Access Compliance Report Public Rights-of-Way (Curb Ramps)

Main Street: FAIRLYNN_BLV		Cross Street: OAKVALE_DR		Location:	NW
ADA ID: RPAT211115144429	Ramp Type: Blended Transition 1	Initial Pass/Fail: Fail	Overall Compliance: No	Severity Score:	15

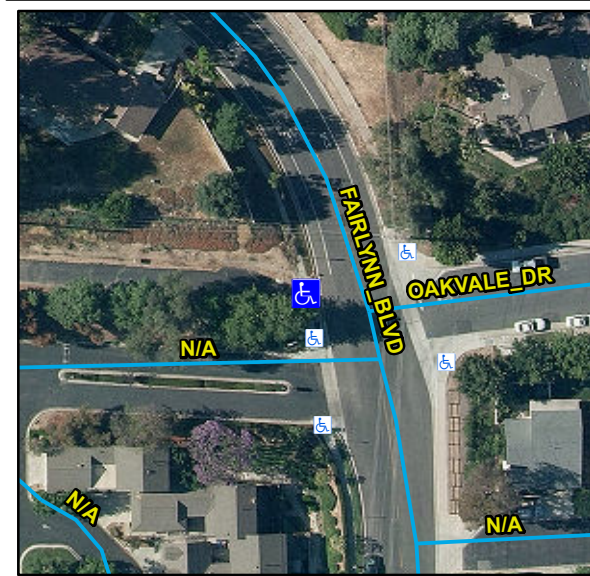
R304.2.2, R304.5.3, STD 1115

Compliance	Description	Data	Compliance	Description	Data
N/A	Ramp Length (in)	84	N/A	Flare Slope LT (%)	N/A
Yes	Ramp Width (in)	144	N/A	Flare Traversable LT	N/A
Yes	Ramp Run Slope (%)	3.4	N/A	Flare Slope RT (%)	N/A
No	Ramp Cross Slope (%)	6.7	N/A	Flare Traversable RT	N/A
N/A	Landing Present	N/A	N/A	DWS Provided	N/A
N/A	Landing Length (in)	N/A	N/A	DWS Contrast	N/A
N/A	Landing Width (in)	N/A	N/A	DWS Length (in)	N/A
N/A	Landing Run Slope (%)	N/A	N/A	DWS Full Width	N/A
N/A	Landing Cross Slope (%)	N/A		DWS Offset Type	N/A
N/A	Landing Movement Obstructed?	N/A	N/A	DWS Offset Left (in)	N/A
	Landing Movement Type	N/A	N/A	DWS Offset Right (in)	N/A
N/A	Landing Shared	N/A			
N/A	Clear Space	N/A			
N/A	Clear Space To Crosswalk (in)	N/A			
N/A	Marked Crosswalk 1	Yes	N/A	Marked Crosswalk 2	N/A
	Crossing 1 Direction	E		Crossing 2 Direction	N/A
	Marked Crosswalk 1 Width (in)	120		Marked Crosswalk 2 Width (in)	N/A
N/A	Ramp Inside Crosswalk 1	Yes	N/A	Ramp Inside Crosswalk 2	N/A

Crossing 1 Slope (%)	6.7		Crossing 2 Slope (%)	N/A
	Crossing 1 Cross Slope (%)	6.4		Crossing 2 Cross Slope (%)	N/A
N/A	Gutter Ponding	N/A	No	Curb Slope	9.1
Yes	Gutter Lip Height (in)	0		Road Run Slope (%)	N/A
N/A	Gutter Run Slope (%)	N/A		Road Cross Slope (%)	N/A
N/A	Gutter Cross Slope (%)	N/A			
Yes	Overall Surface Condition	Acceptable			
	Cross Gutter Present?	No		Spandrel Present?	No
	Replace Cross Gutter?	N/A		Replace Spandrel?	N/A

Remove & Replace Curb Ramp With Two New Directional Ramps or Equivalent.
